FINAL PLAT THE TRAILS FILING No. 10

A SUBDIVISION OF PORTIONS OF THE SOUTHWEST QUARTER OF SECTION 16 AND THE SOUTHEAST QUARTER OF SECTION 17,
TOWNSHIP 12 SOUTH, RANGE 64 WEST OF THE THE SIXTH PRINCIPAL MERIDIAN, COUNTY OF EL PASO, STATE OF COLORADO.

PCD FILE No. SF-24-21

Sheet 3 of 5

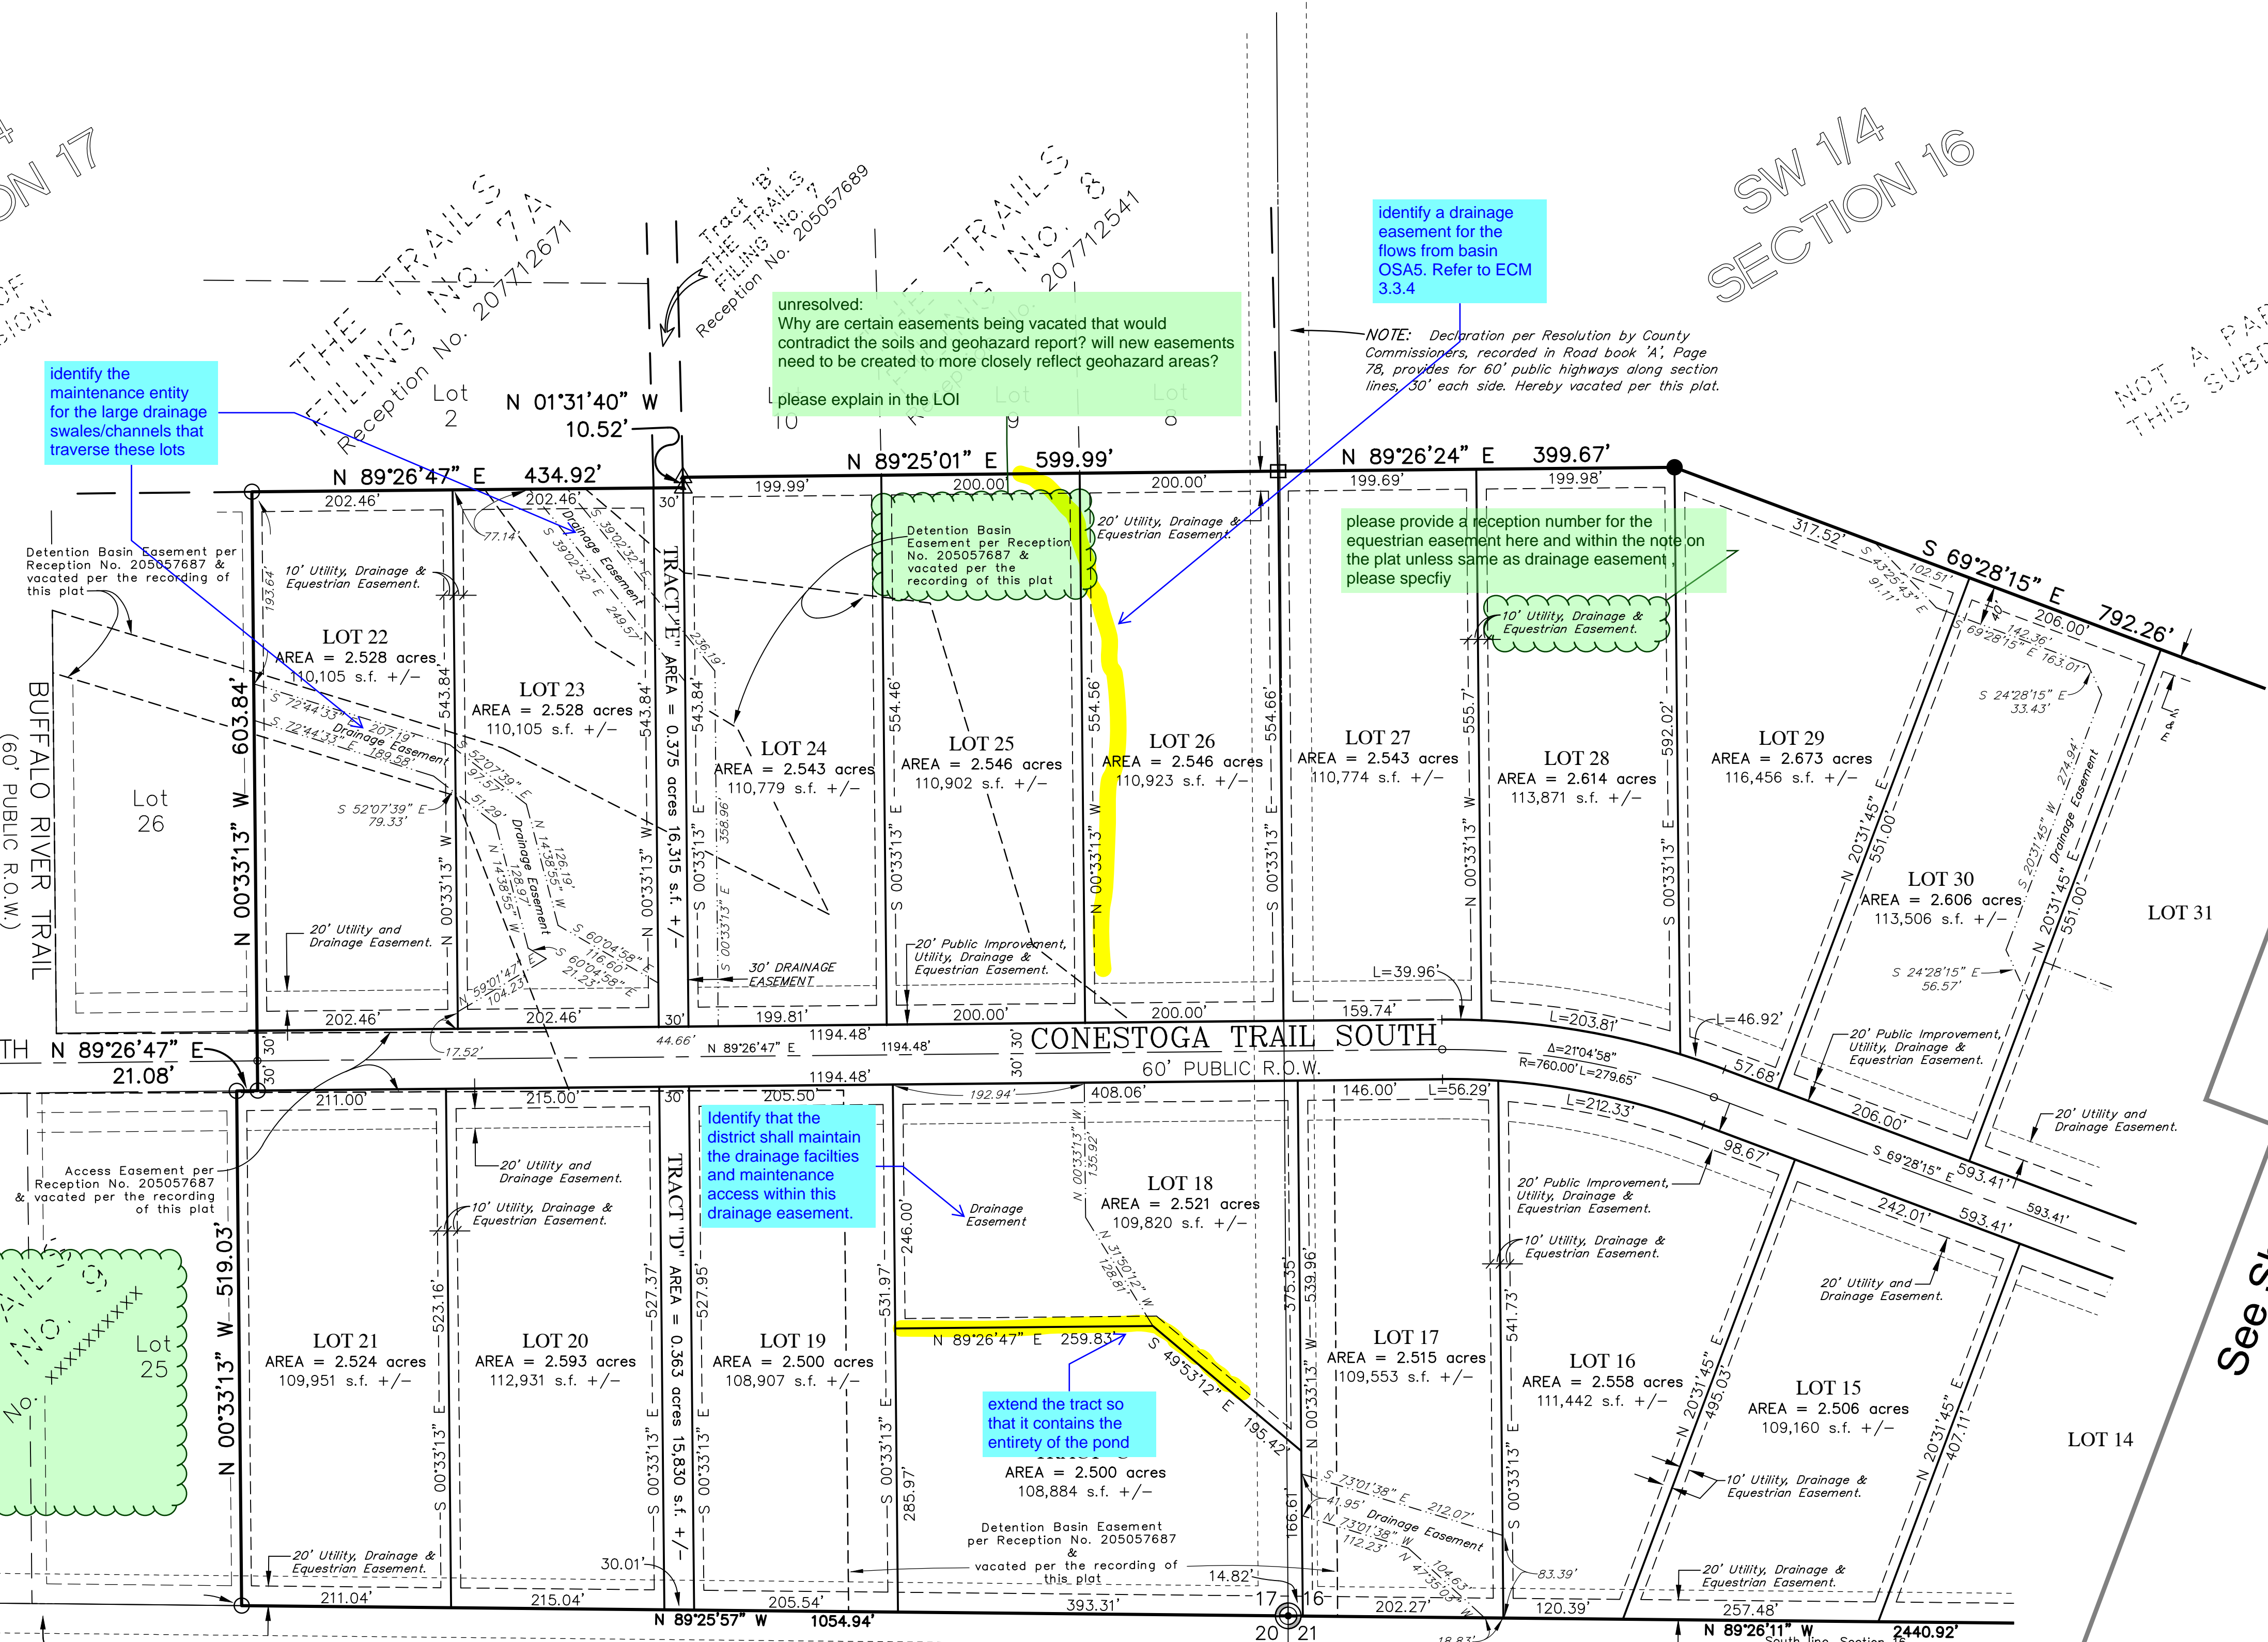
Unresolved:
Add reception number

identify the maintenance entity for the large drainage swales/channels that traverse these lots

unresolved:
Why are certain easements being vacated that would contradict the soils and geohazard report? will new easements need to be created to more closely reflect geohazard areas?
please explain in the LOI

identify a drainage easement for the flows from basin OSAS. Refer to ECM 3.3.4

please provide a reception number for the equestrian easement here and within the note on the plat unless same as drainage easement please specify

Identify that the district shall maintain the drainage facilities and maintenance access within this drainage easement.

extend the tract so that it contains the entirety of the pond

Sheet 5 of 5

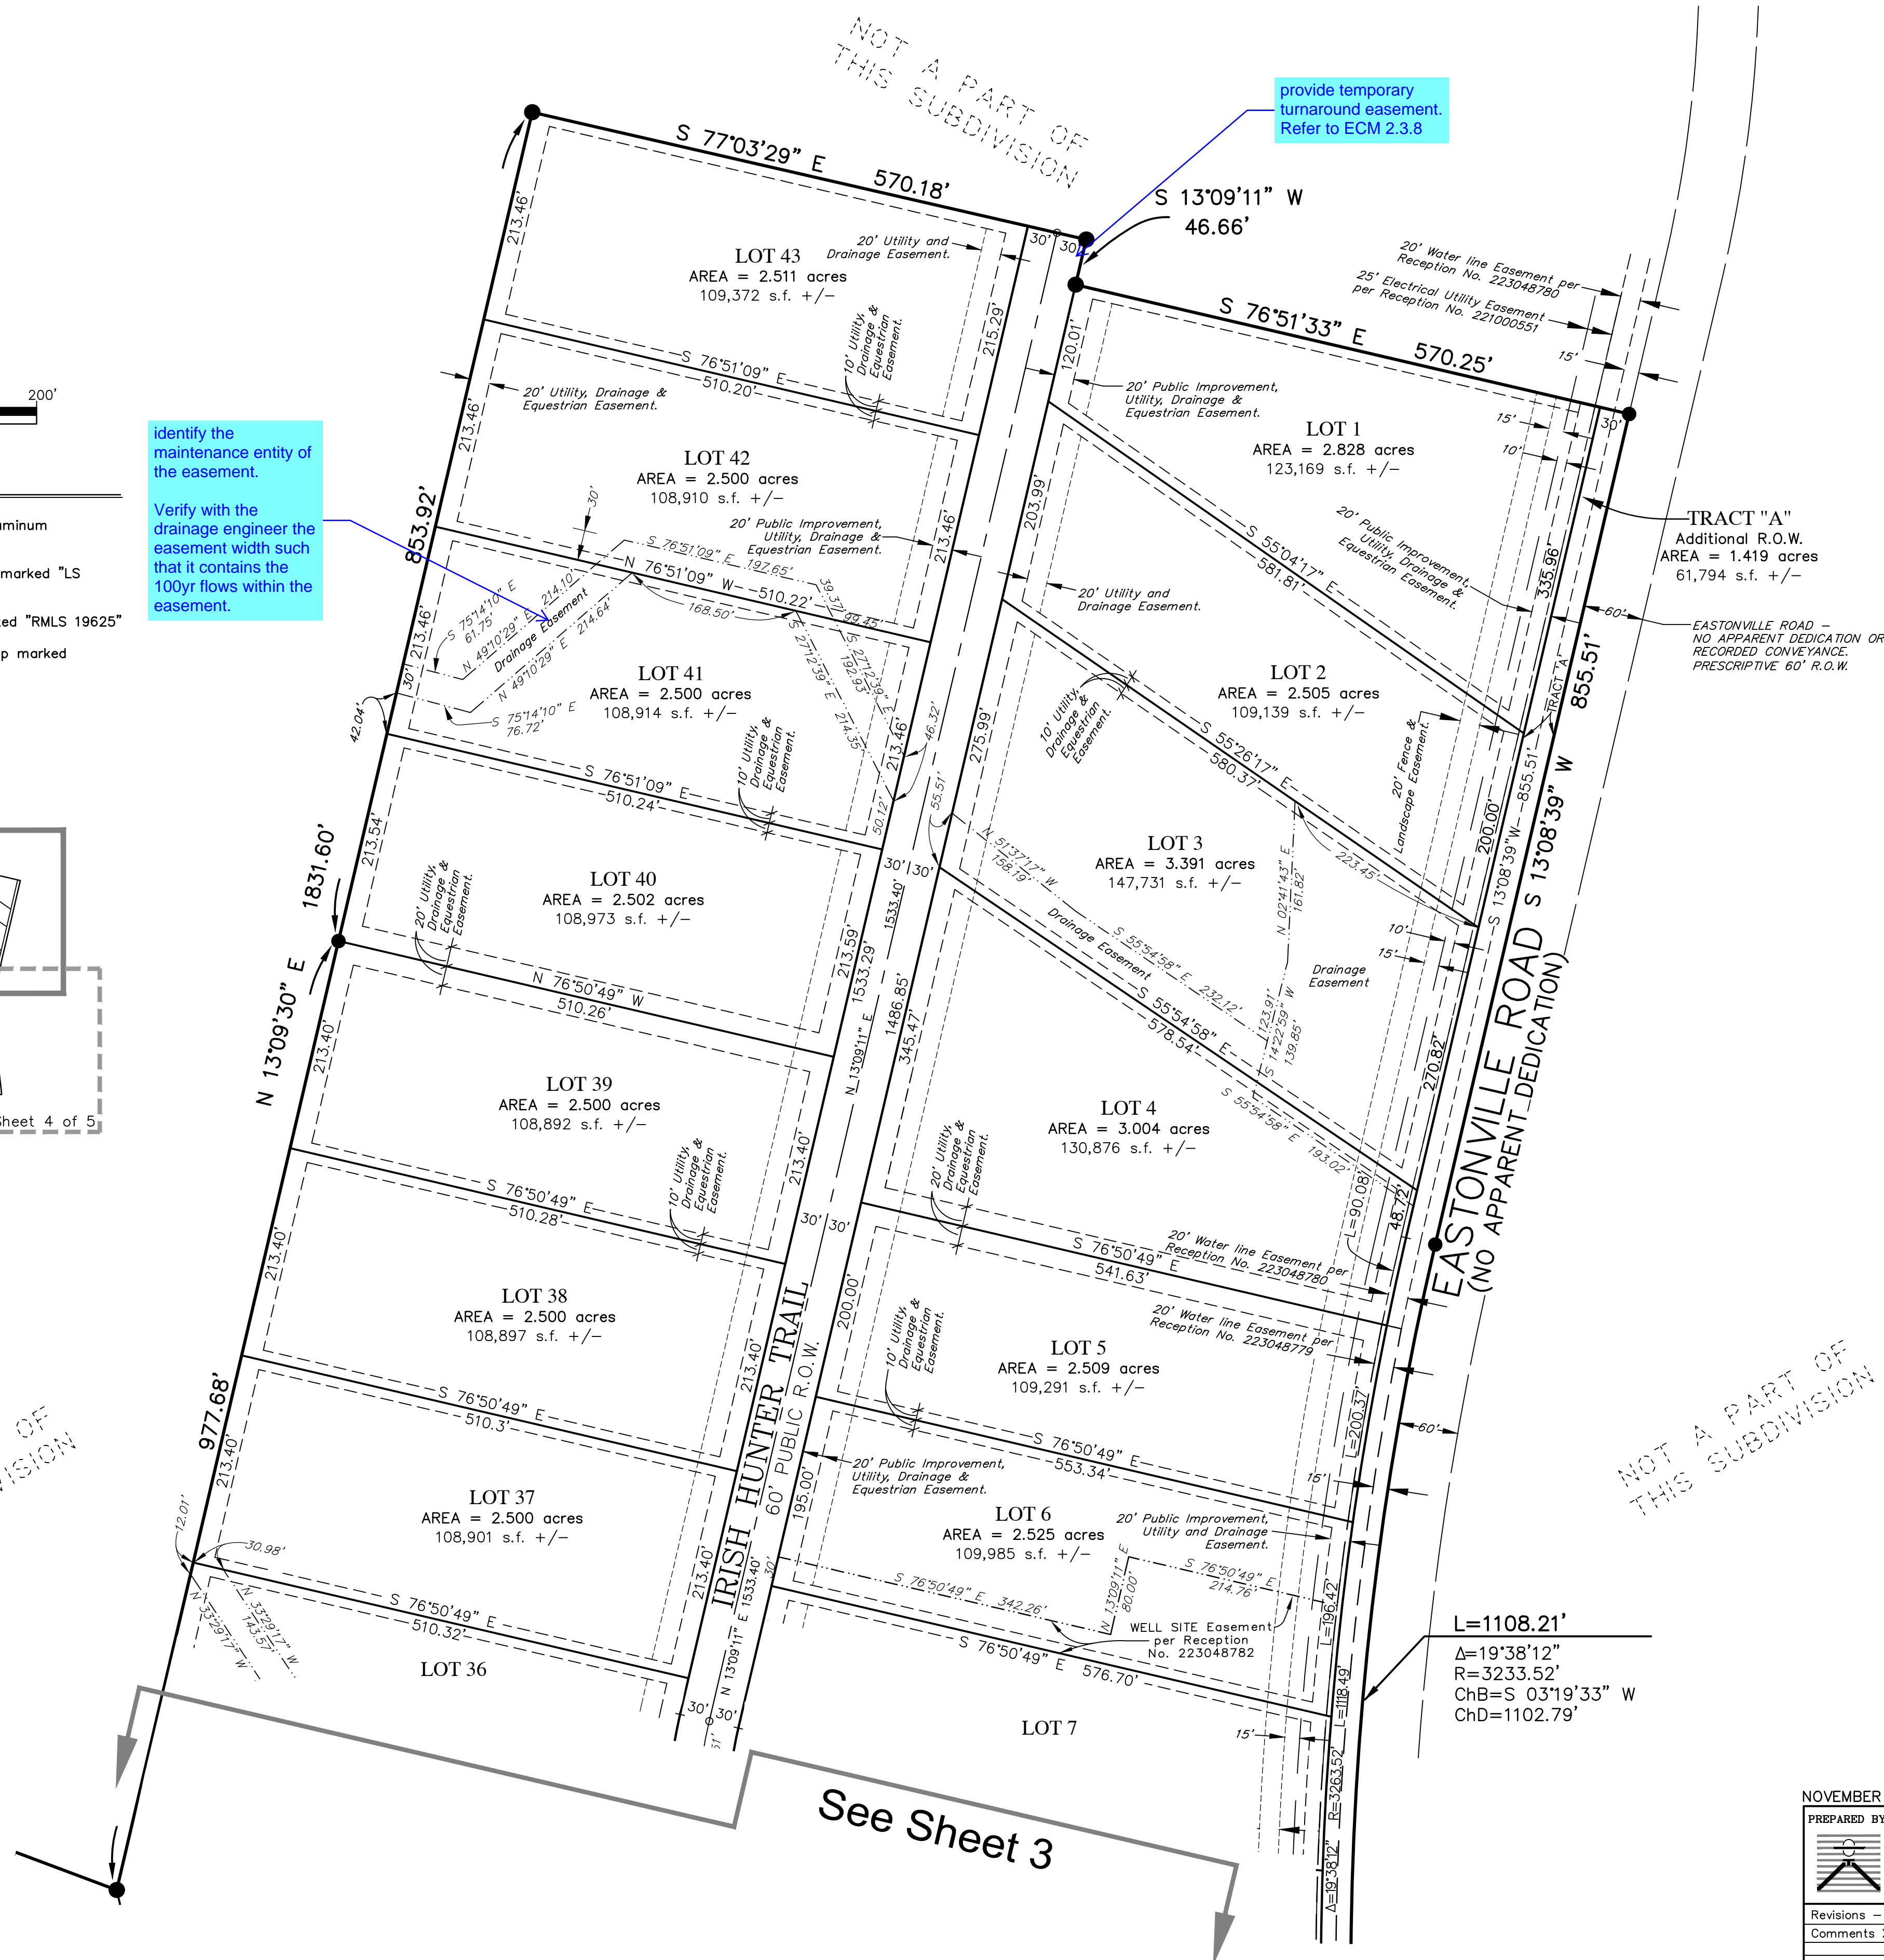
identify the maintenance entity of the easement.

Verify with the drainage engineer the easement width such that it contains the 100yr flows within the easement.

provide temporary turnaround easement. Refer to ECM 2.3.8
